**City of Newton, Massachusetts**  
Department of Planning and Development  
1000 Commonwealth Avenue Newton, Massachusetts 02459

## MEMORANDUM

**DATE:** October 9, 2020

**RE:** **#88-20 Discussion and review relative to the draft Zoning Ordinance**  
DIRECTOR OF PLANNING requesting review, discussion, and direction relative to the draft Zoning Ordinance.  
**Other docket items to be taken up within the context of Zoning Redesign include #30-20, #38-20, and #148-20**

**Lot Standards**

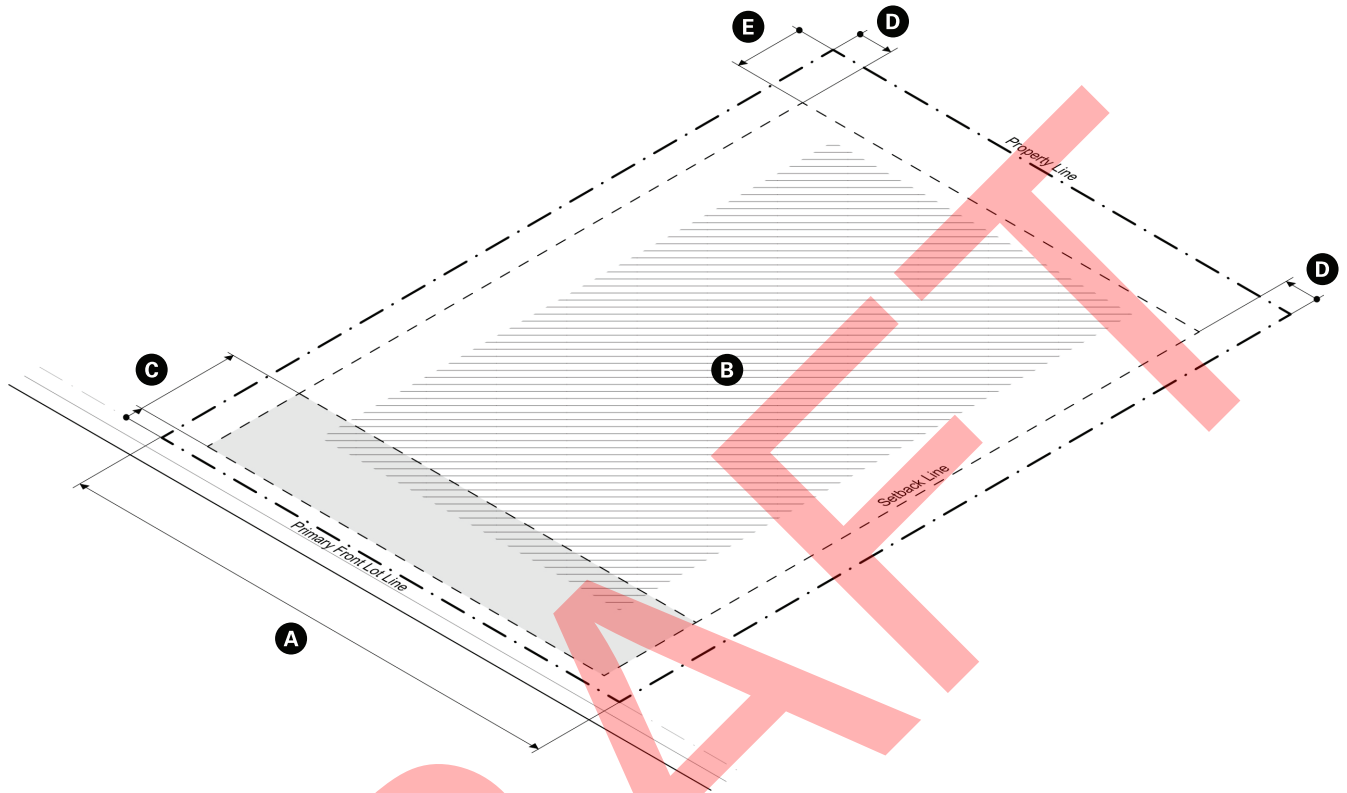
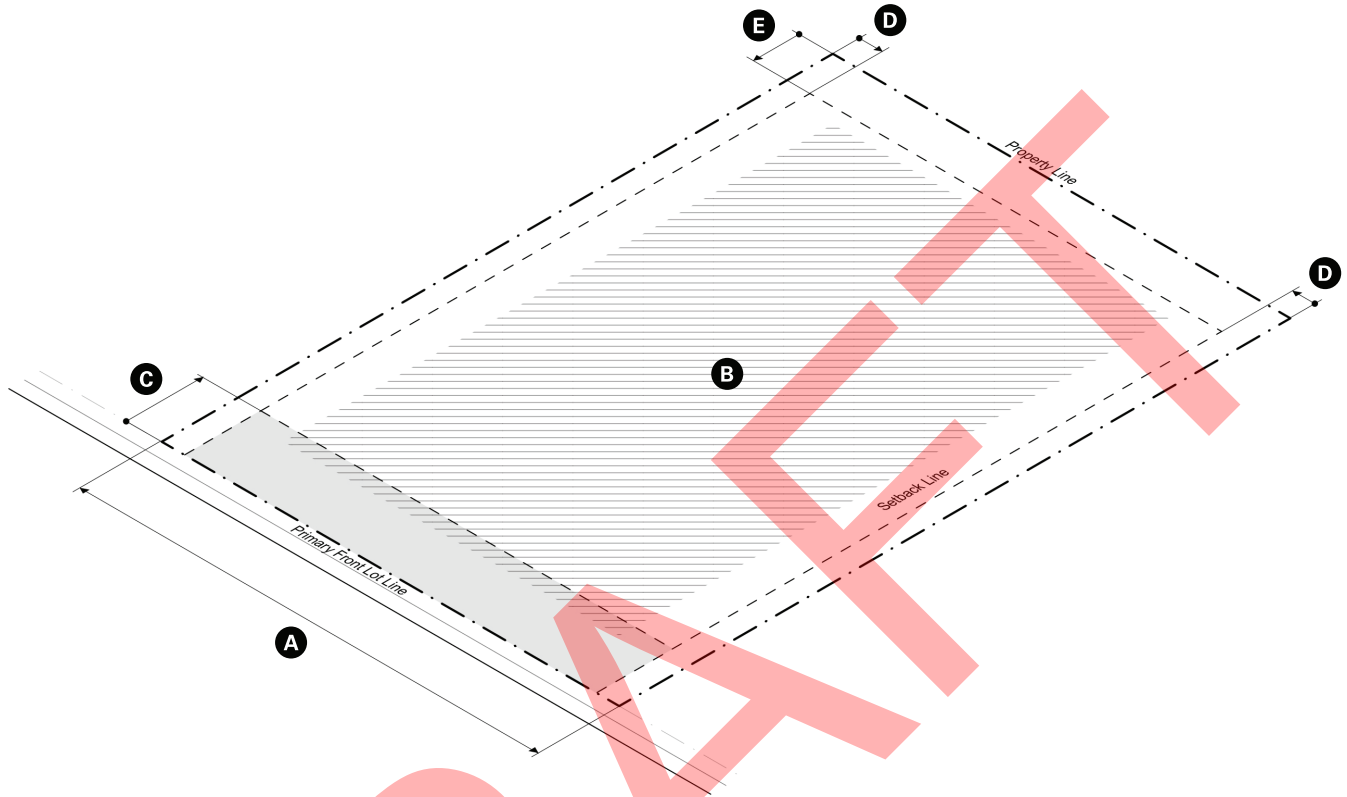
Since releasing the latest draft in August, staff have worked with our design and planning consultant on additional recommendation changes to further simplify the draft zoning and further ensure that Courtyard Clusters appropriately fit within Newton’s neighborhoods (Attachment C). These include:

- Does the new proposed Building Type better facilitate development in scale and proportion with the intent and definition of Courtyard Clusters?
- Should the parking requirements be reduced since Courtyard Clusters are limited to areas walkable to public transit and village centers?
- Almost all standards for Courtyard Clusters are specific to this development type (i.e. Lot Frontage, Lot Coverage, and Building Type), with setbacks as the exceptions (set by the district). To further simplify the code, should there be separate setbacks specifically for Courtyard Clusters, no matter which district?

Lot Characteristics	min	max
Lot Size	0.75 ac	--
<b>A</b> Frontage	50 ft	--
<b>B</b> Lot Coverage	--	50%
Lot Setbacks	min	max
<b>C</b> Front	5 ft	35 ft
<b>D</b> Side	10 ft	--
<b>E</b> Rear	20 ft	--

Lot Characteristics	min	max
Lot Size	0.75 ac	--
<b>A</b> Frontage	50 ft	--
<b>B</b> Lot Coverage	--	60%
Lot Setbacks		min
<b>C</b> Front	0 ft	25 ft
<b>D</b> Side	7.5 ft	--
<b>E</b> Rear	15 ft	--

3.2.x. Courtyard Cluster House

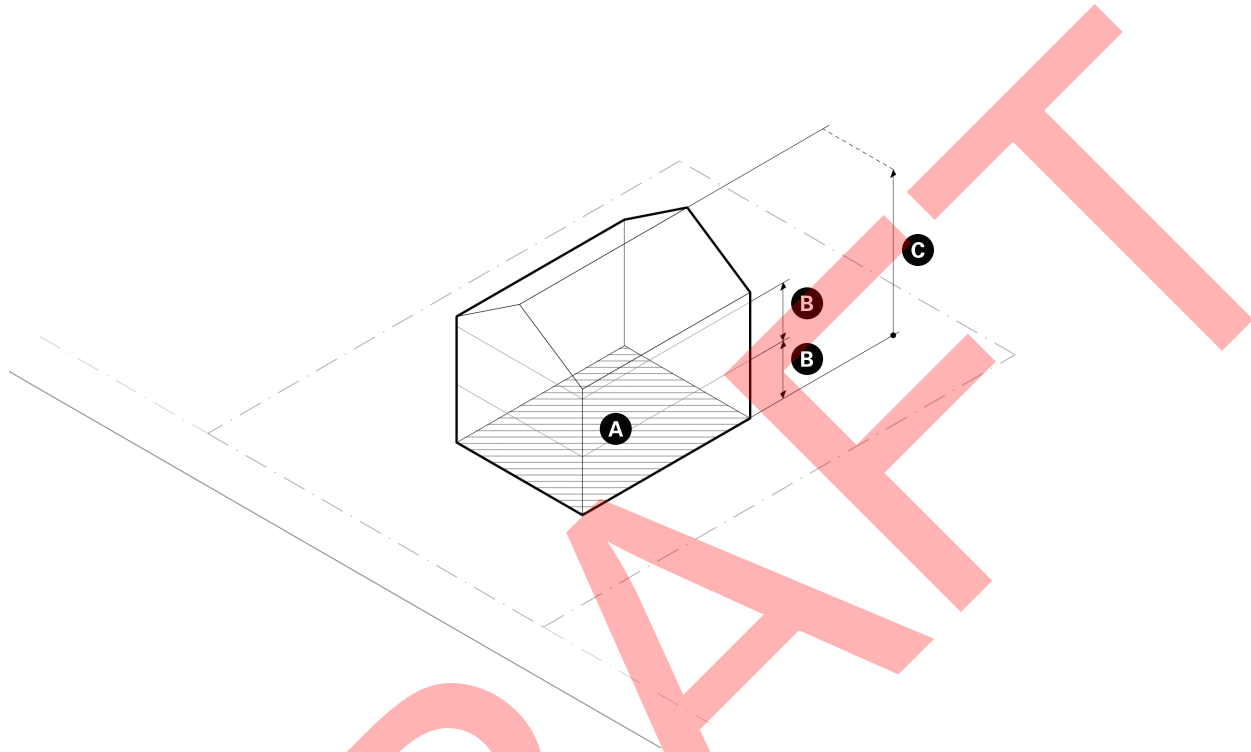
- Developing a standalone Courtyard Cluster Building Type (Attachment D). The draft Courtyard Cluster Building Type standards for review are:

Previous versions utilized the proposed Housing Types with a reduced footprint. Staff believe this is overly complicated and would have allowed for development that did not align with the Committee's intent for Courtyard Clusters (i.e. 3-story, 3-unit buildings). Staff is working to refine this Building Type and are seeking guidance from the Committee, see questions below.

<b>Building Dimensions</b>	min	max
<b>A</b> Building Footprint	--	1,200 sf.
<b>B</b> Story Heights	--	12 ft
<b>C</b> Number of Stories	--	2.5 stories

**Courtyard Requirements and Parking**  
*Illustration shows N District*

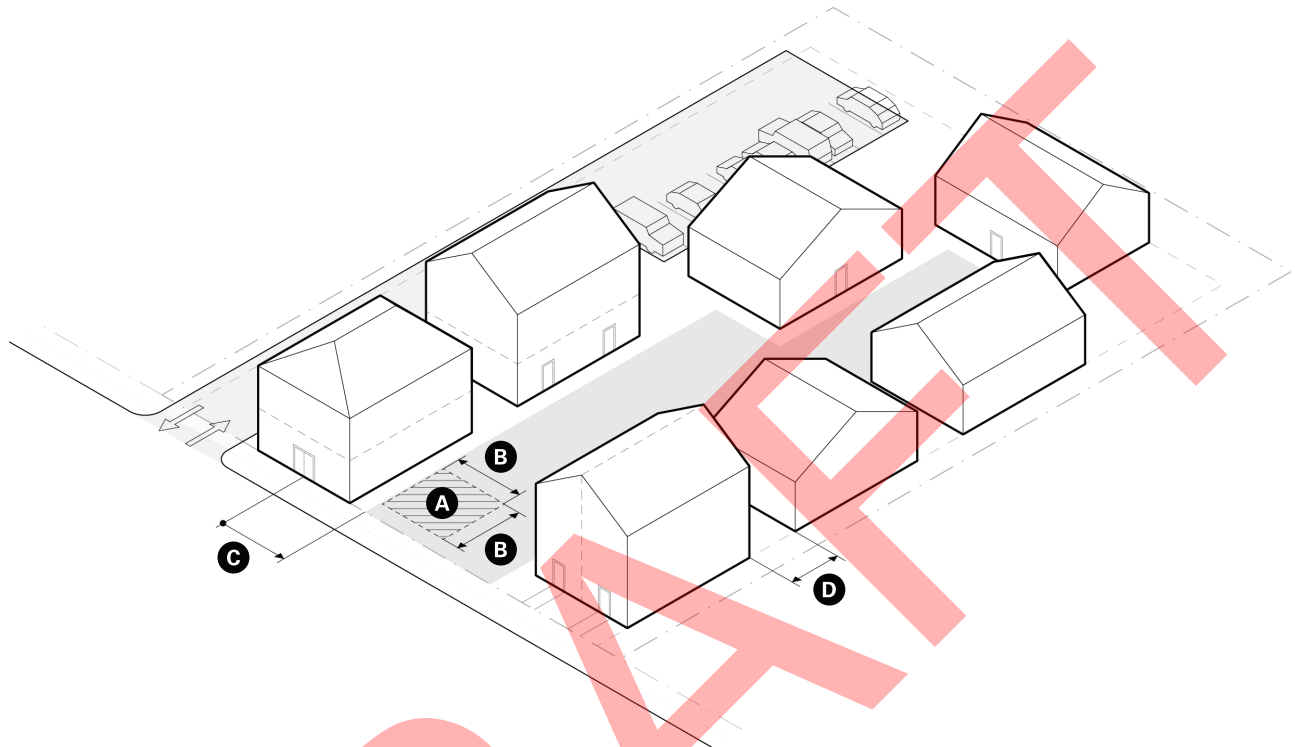
- Establishing a minimum distance between each building of 15 feet (Sec. 3.5.3.C.4) Previous versions had no required minimum distance. Rather than rely on the building code, which requires a variety of distances based on multiple factors (construction type, occupancy, fire-resistance rating, etc.), we have worked with our consultant to determine an appropriate distance that not only satisfies the building code, but also the neighborhood context.

<b>Courtyard Requirements</b>	min	max
<b>A</b> Area of courtyard per unit	400 sf	--
<b>B</b> Width and depth of courtyard per unit	20 ft	--
<b>C</b> Distance from building front door to the edge of the courtyard	--	60 ft
<b>D</b> Distance between buildings	15ft	--
